Service Note		
Product	Description:	Service note no.
<b>G-Force</b>	<b>Modifications to Main board, PC13002-2</b>	<b>720 10 T030</b>

This document describes the modifications made on the G-Force Main PCB, ver. PC13002-2. The modifications are made from factory on all units with serial no. 1400200 or higher. Modifications should only be carried out by authorized technicians.

Figure 0

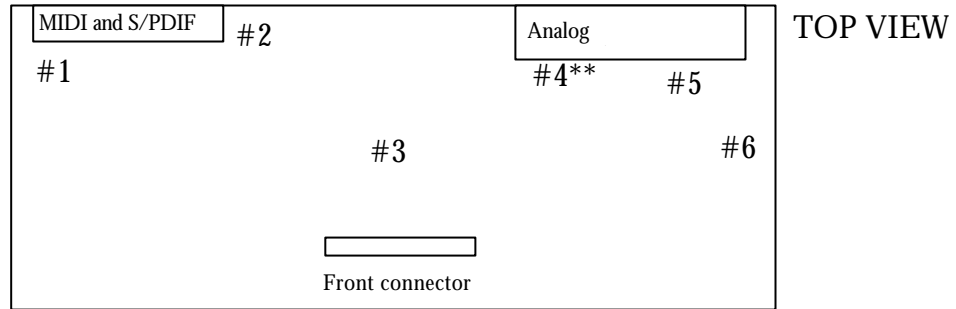
Figure 0 shows where the modifications are made on the PCB.

\*\* Modification 4 is made on the bottom side of the PCB.

Figure 1

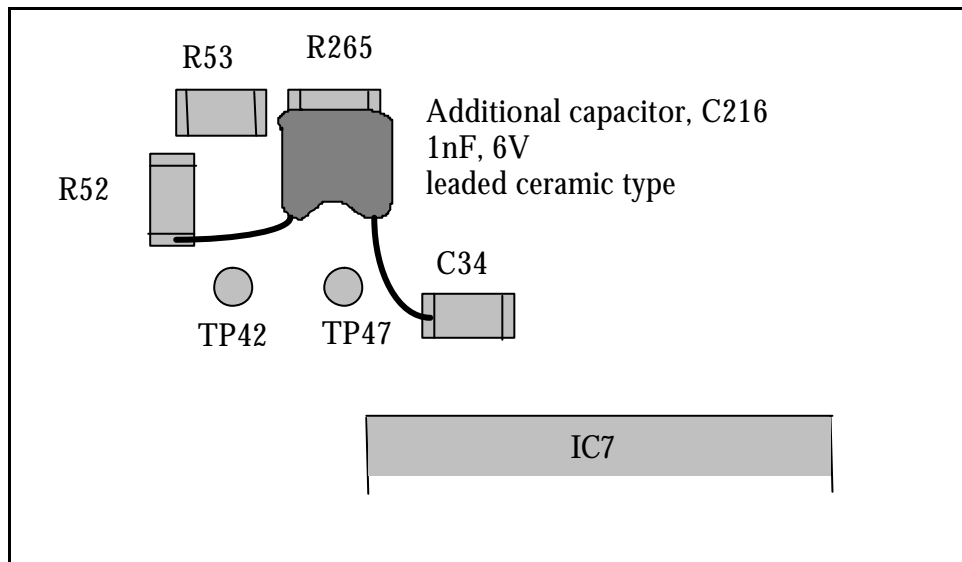
**Modification 1 (for further information refer to page 9 in main schematics) :**

An additional capacitor (C216) is mounted between R52 and C34 on PCB top as in figure 1.

Figure 2

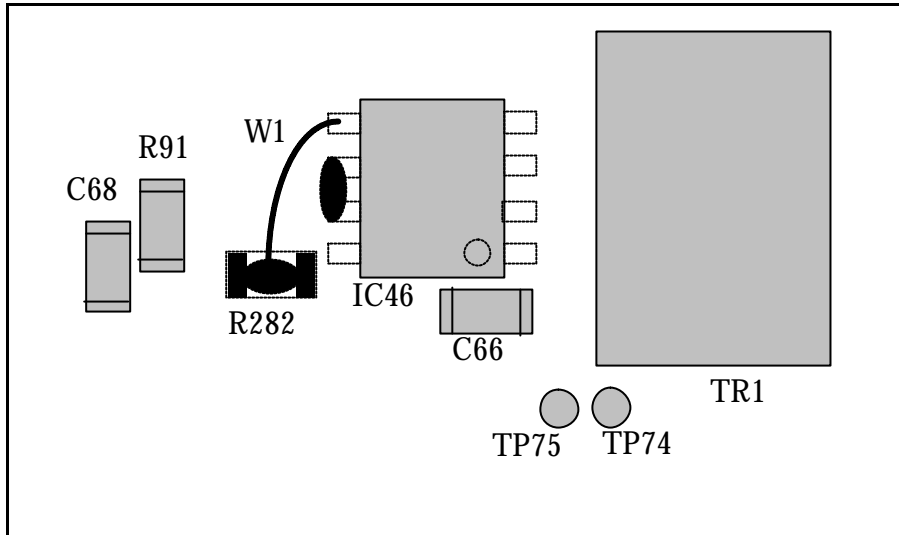
**Modification 2 (for further information refer to page 4 in main schematics) :**

R282 is not mounted. R282 is short circuited instead. An additional wire (W1) is mounted between R282 and IC46, pin 5. IC46, pin 6 and pin 7 are short circuited. Everything is made on PCB top as showed in figure 2.

Figure 3

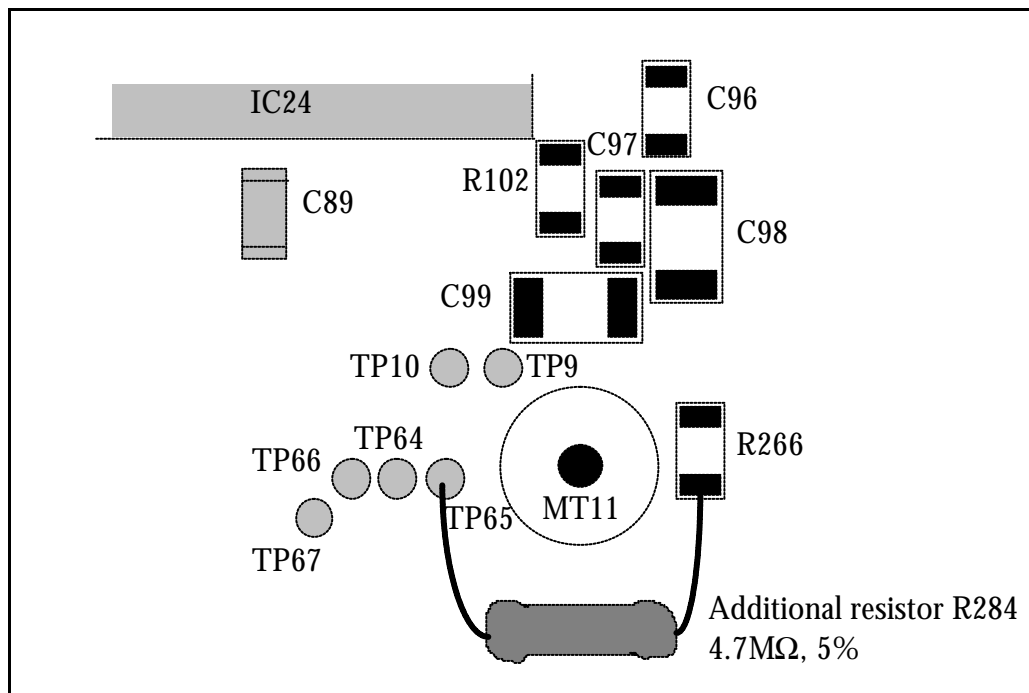
**Modification 3 (for further information refer to page 7 in main schematics) :**

An additional resistor (R284) is mounted on PCB top between R266, which is not mounted, and TP65. It is showed in figure 3.

Figure 4

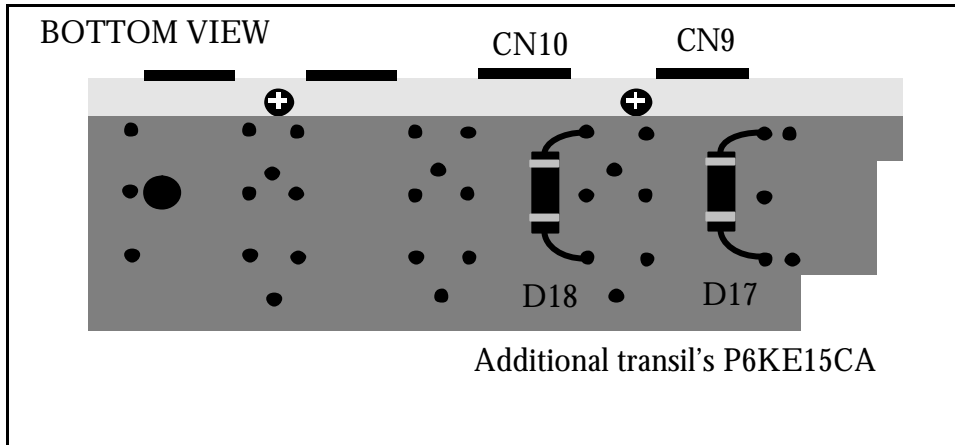
**Modification 4 (for further information refer to page 13 in main schematics) :**

Two additional transil's (D17 and D18) are mounted on PCB bottom under the analog output jacks as shown in figure 4.

Figure 5

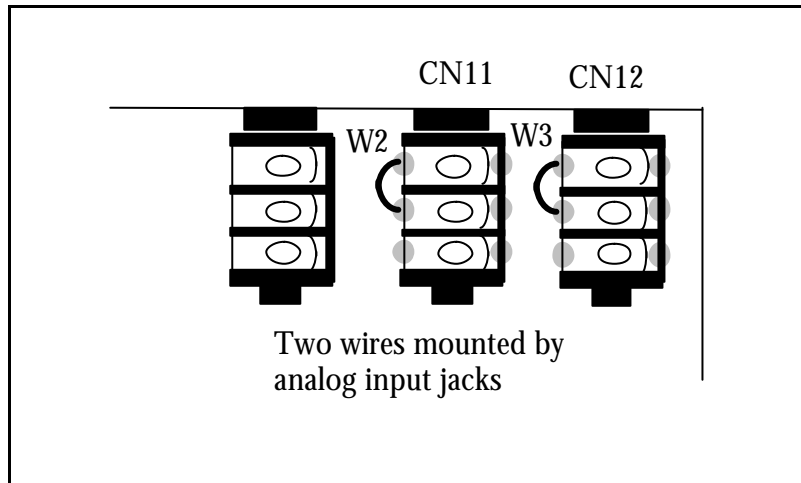
**Modification 5 (for further information refer to page 13 in main schematics) :**

Two additional wires (W2 and W3) are mounted by each analog input jack connecting the jack ring to jack shell. Shown in figure 5.

Figure 6

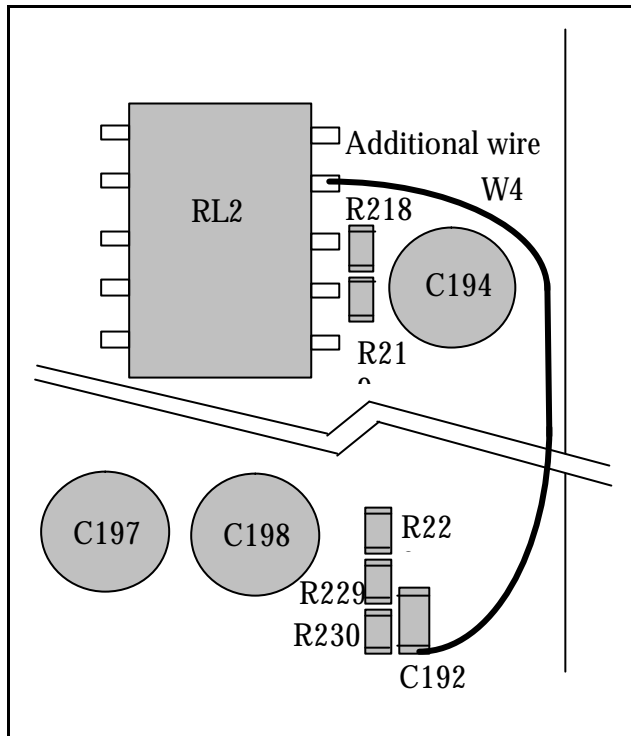
**Modification 6 (this modification makes no changes in schematics) :**

C192 is removed for a moment and the pad under C192 is removed

Then C192 is mounted again and a wire (W4) from C192 (negative pole) to RL2, pin 9 is mounted as shown in figure 6.
